HORSHAM DISTRICT COUNCIL CONSULTATION

TO:	Horsham District Council – Planning Dept
LOCATION:	Land Parcel at 519531 134037 Rusper Road Horsham West Sussex
DESCRIPTION:	Reserved Matters application (layout, scale, appearance, internal access and landscaping) pursuant to Condition 5 of Outline Planning Permission reference DC/16/1677 for RM Area 12 comprising 278 (C3 Use) residential units, car and cycle parking, play area, drainage, internal roads, and associated infrastructure.
REFERENCE:	DC/26/1241
RECOMMENDATION:	Advice / More info / Modification to Plot P7,1
SUMMARY OF COMMENTS & RECOMMENDATION: The application is supported by an Arboricultural Impact Assessment, Arboricultural Method Statement and Tree Protection Plan prepared by David Jarvis Associates. The submitted information advises that the proposed layout has been designed to retain all Category A and B trees The site adjoins Castle Copse, a designated area of Ancient Woodland (AW). The AW has been allocated a minimum 15m ancient woodland buffer and submitted information confirms that all built development is located outside the of the buffer as such no direct impacts upon the woodland have been identified. The principal

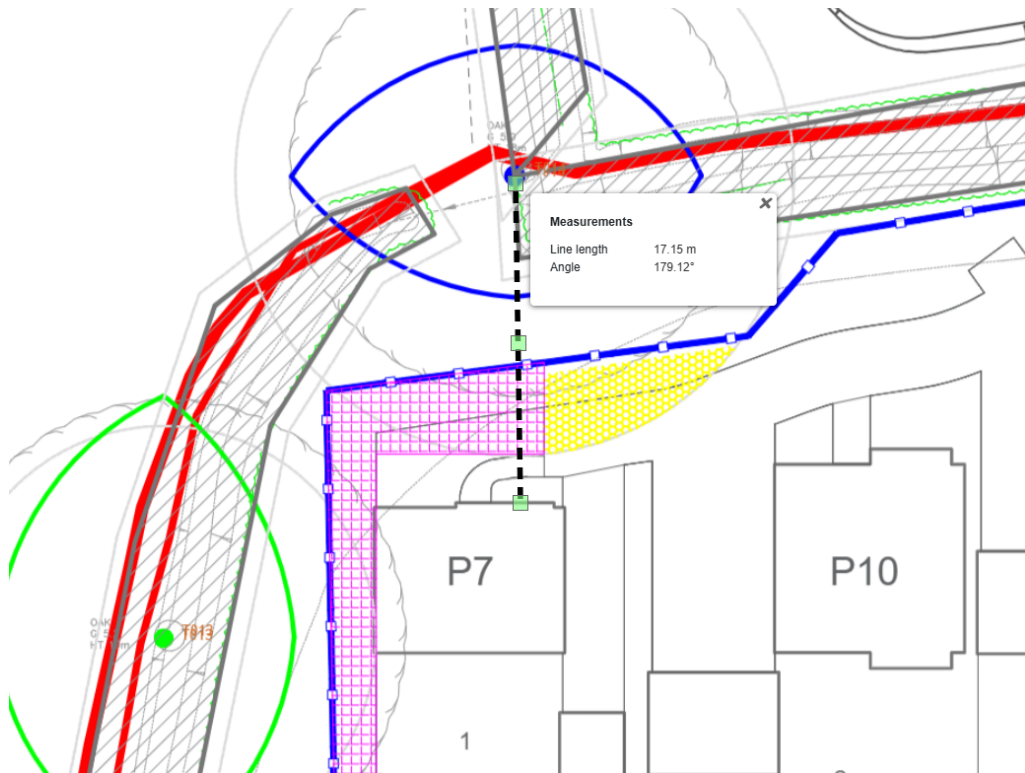
The proposed RPA incursion associated with T014, appears to be the largest occurrence, and is stated to affect approximately 17.5% of the otherwise undeveloped RPA. In this regard it is noted that the ditch to the south of the tree may have influenced rooting in the area where the encroachment occurs; please seek confirmation on this.

Furthermore, as previously advised in the response to DC/26/1242, concerns remain regarding the proposed footway connection along the northern boundary between the application site and the land to the north, where the route passes within the RPA of T024. Whilst a low-dig construction methodology is proposed, the assessment appears to assume that the footway can be installed without significant ground modification due to the location of existing ditch/depression along this section of the northern boundary which separates the application site from the land to the north, it is likely that this feature would need to be bridged, spanned or partially infilled. As such, it remains unclear whether the proposed low-dig specification can be delivered in practice without causing additional impacts within the RPA of T024; please seek confirmation on this.

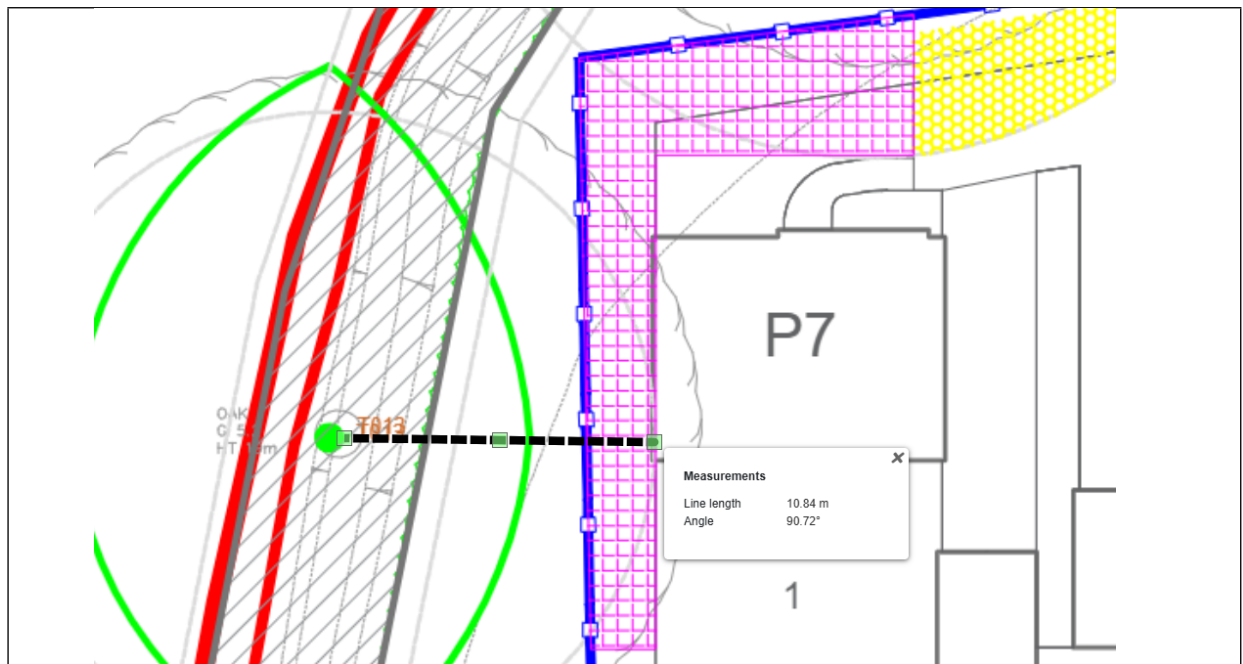
It is noted that T014, is an open-grown Pedunculate Oak with a stem diameter in excess of 1,000mm, is recorded as exhibiting basal stem decay, a possible historic lightning

strike, numerous cavities, decay pockets and deadwood, all of which are veteran features; the survey recommends that the tree be retained within a low-occupancy area. T014 is positioned immediately north of Plot P7,1 and is approximately 17m from the front elevation of the proposed dwelling, which would be considered to represent a high occupancy area, thereby, the location of unit p7,1 dose not appear to be sustainable, and hasten appropriately considered the Arboricultural advise relating to the trees retention within a low-occupancy areas, which is far from ideal.

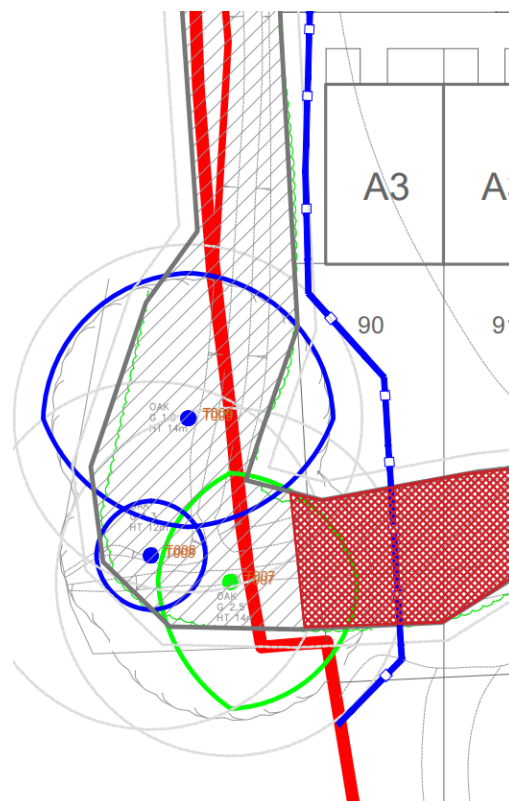
Tree T013 is located approximately 11m from the western flank wall. The submitted Tree Protection Plan also indicates that the crown of T013 extends over the proposed unit. The existing canopy overhang also raises questions as to whether pruning may be required to facilitate construction and maintain suitable post-development clearances.

Similarly, trees T007 and T009 are positioned along the western boundary of Plot A3, 90 and are likely to have a significant influence on the rear garden area through shading and canopy presence.
